Our Case Number: ABP-316272-23

Re: Bus Connects Templeogue/Rathfarnham to City Centre Core Bus Corridor Scheme
Templeogue/Rathfarnham to City Centre

Submission re Templeogue/Rathfarnham to City Centre Core Bus Corridor Scheme

Figure 2 – Extract Map H Dublin City Development Plan 2016-2022

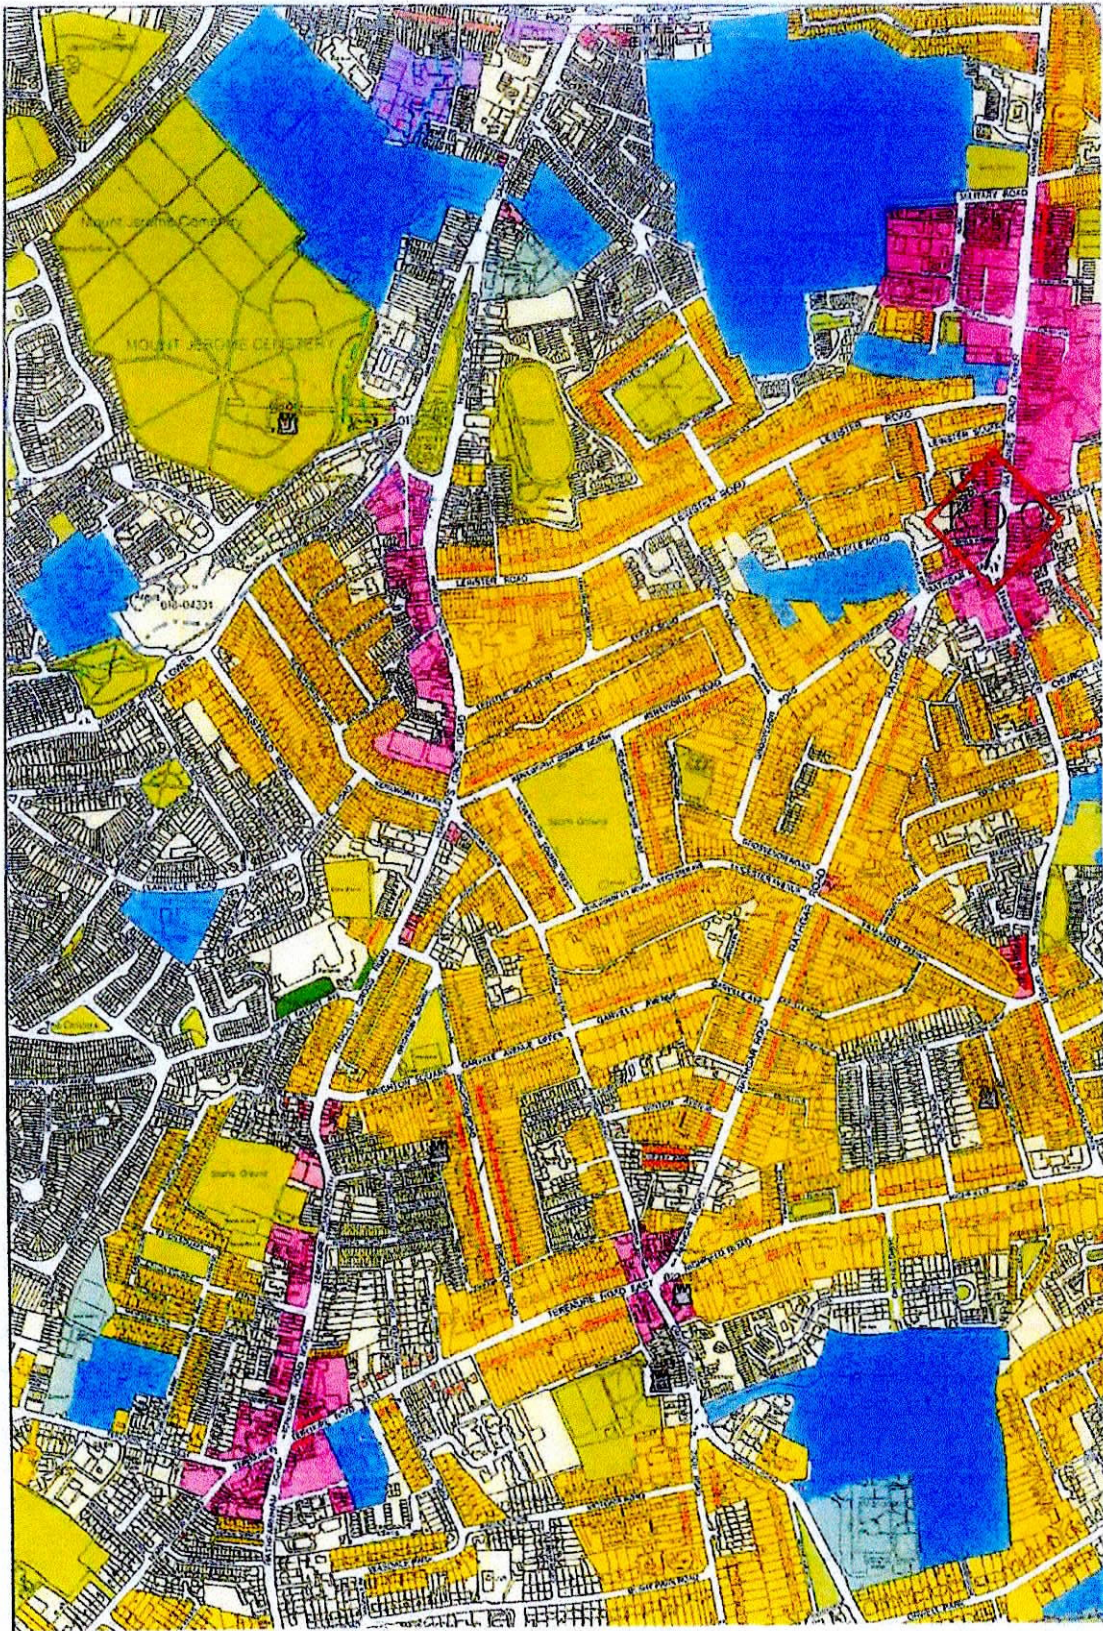
4.18 Figure 2 above is an extract from Map H of the City Plan, and shows the area in question extending from Terenure at the west along Terenure Road East and along Rathgar Road Rathmines at the north east. The bright yellow shading indicates use zoning objective Z2 denoting a residential Conservation Area, and the red dots on the properties along both roads indicates that the subject property is included on the Council's Record of Protected Structures. Both roads comprising the section of the emerging preferred route for CBC 12 between Terenure and Rathmines enjoy the protections under both designations in the City Plan, confirming the significance and the sensitivity of the existing environment in architectural heritage and conservation terms. As the emerging preferred bus corridor route extends the length of both roads and passes through the urban villages, the impact upon the historic fabric will be profound and seriously injurious.

- 4.25 As shown on Figure 2 above, the majority of the residential areas centred around Rathgar village and extending from the village westwards on Terenure Road East, eastwards along Highfield Road, northeast on Rathgar Road and north along Rathgar Avenue are classified as Conservation Areas where the use zoning objective is Z2. These areas are shown bright yellow on Figure 2 and have been designated as Conservation Areas to recognise "their special interest or unique historic and architectural character and important contribution to the heritage of the city."

- 4.31 It is useful to compare and contrast the use zoning objectives and the extent of protected structures along both principal routes within Corridor E of the GDA Transport Strategy. Both routes are seen on Figure 2 above. As noted already, most of the residential areas along Terenure Road East and virtually the entire of Rathgar Road is zoned Z2. The works envisaged will affect up to 202 protected structures in total on both roads, or more than 302 if the protected properties at Rathmines Road Lower are also included.

Figure 4 Extract GDA Cycle Network Plan [NTA 2013]

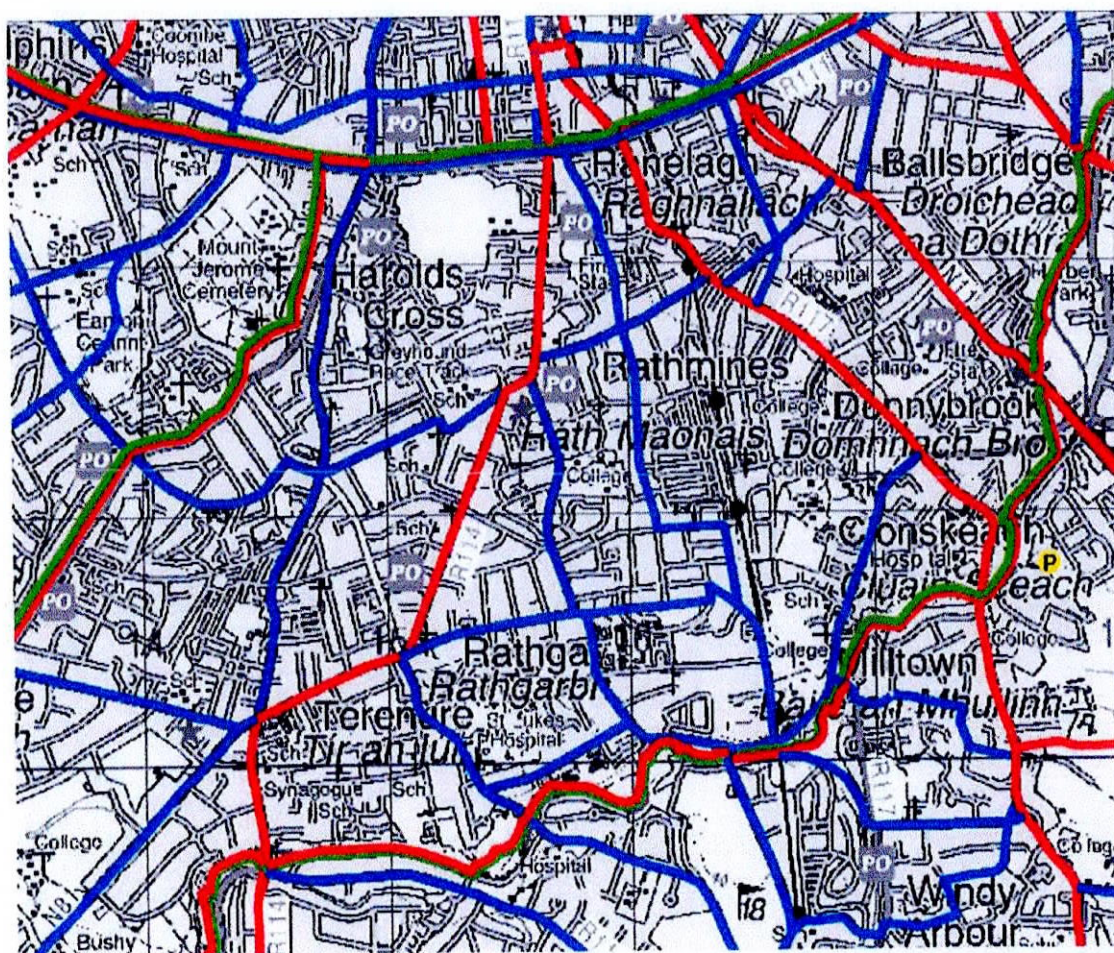
7.1 In response to your invitation for comments on the emerging preferred scheme, we respectfully request you to examine the following suggested alternative for core bus corridor 12. We believe there is a viable alternative whereby the core bus corridor between Rathfarnham and the City Centre passes through Terenure village and Harold's Cross village with the cycle lane provided on a separate alignment following the primary cycle route 10 in the GDA Cycle Network Plan [see Figure 4 below].

- 7.2 Primary Cycle Route 10 is denoted by the solid red line from Rathfarnham to Terenure turning onto Terenure Road East passing through Rathgar village and along Rathgar Road to Rathmines. Secondary routes are indicated in blue and include options for cyclists at Terenure via Terenure Road North and at Rathgar via Highfield Road and Rathmines Road Upper for city-bound cyclists or other local variations as shown above.
- 7.3 A segregated bus lane via Harold's Cross together with the primary cycle route 10 along Terenure Road East and Rathgar Road achieves both objectives in the core bus corridor scheme, and also addresses many if not all of the disadvantages of the current emerging preferred route. The suggested alternative for this core bus corridor is shown in Figure 5 below. Some advantages of this alternative are set out below.

Figure 5: Suggested Alternative Core Bus Corridor 12

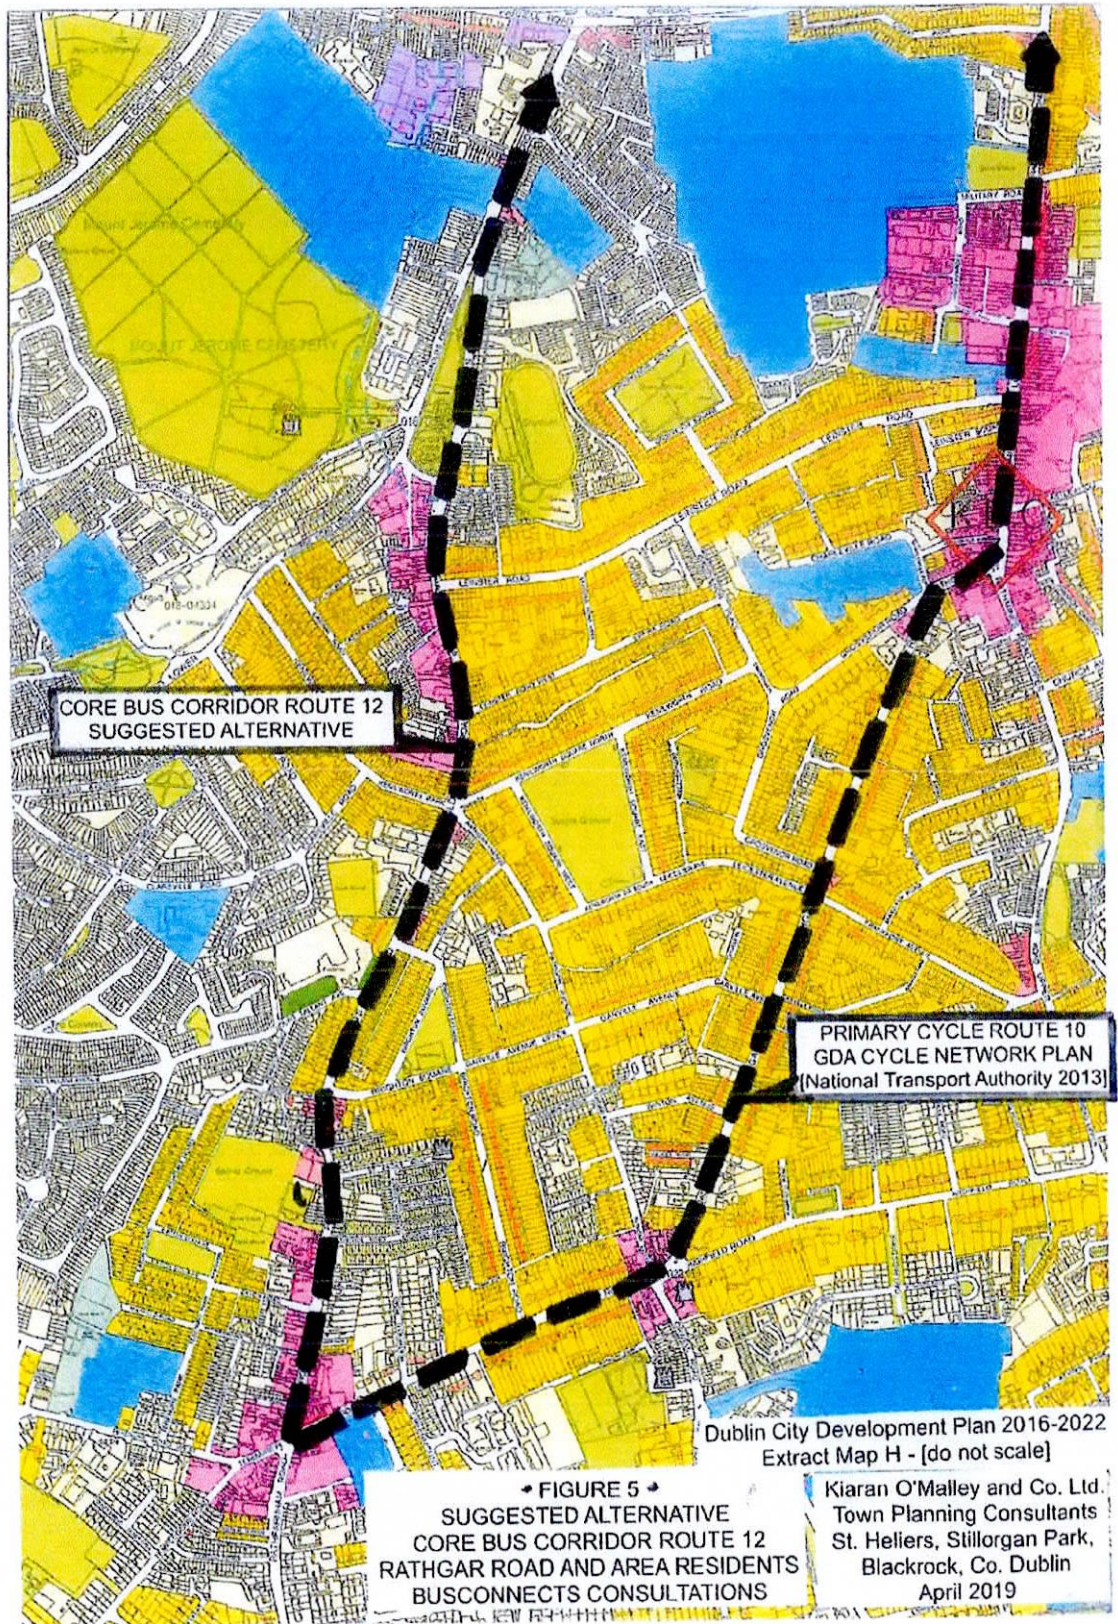
- 7.4 Figure 5 shows the suggested alternative with core bus corridor route 12 continuing straight onto Terenure Road North at Terenure village, avoiding the right hand turn at Terenure Road East for city bound buses from Rathfarnham. This routing also eliminates the conflict between cyclists and buses in the current proposed route.

- 7.5 Terenure Road North is wider than Terenure Road East at this junction and it appears capable of accommodating bus traffic. As the Primary Cycle Route 10 is at Terenure Road East and Rathgar Road as per the Cycle Network Plan, the extent of land take along Terenure Road North may be reduced if that road does not include 2 x 2m cycle lanes.

- 7.6 In the event it is decided to provide two cycle lanes at Terenure Road North, any land acquisition if required, does not involve the extensive loss of curtilage from hundreds of protected structures or the permanent damage to architectural heritage and urban fabric associated with the emerging preferred route. Virtually none of the areas alongside the suggested alternative route are classified as residential conservation areas. Together with the avoidance of incalculable damage to the built environment, there may be considerable cost savings due to the reduced land take involved. The quantum of any reduction in acquisition costs and accommodation works savings are subject to detailed survey and project design.

- 7.7 Another benefit of the suggested alternative routing is that the segregated cycle lane on Terenure Road East and Rathgar Road can be provided within the existing carriageway without the need for costly road widening and environmental damage on a city-wide scale. Moreover, the resulting cycle lane would deliver the route identified in the Cycle Network Plan, which has the potential to become a major radial cycle route for large volumes of cyclists accessing the city. This cycle route will pass through an inner suburb recognised for its distinct character and identity and it can contribute positively to the attractiveness of the area satisfying another requirement of the City Development Plan. A safe segregated route through Terenure, Rathgar and Rathmines to the city centre is also likely to attract new cyclists and help drive greater modal shift from private vehicles, which is at the heart of the over-arching planning policy and sustainable transport plans. We submit therefore that the suggested alternative as shown on Figure 5 is consistent with the proper planning and sustainable development of the city.
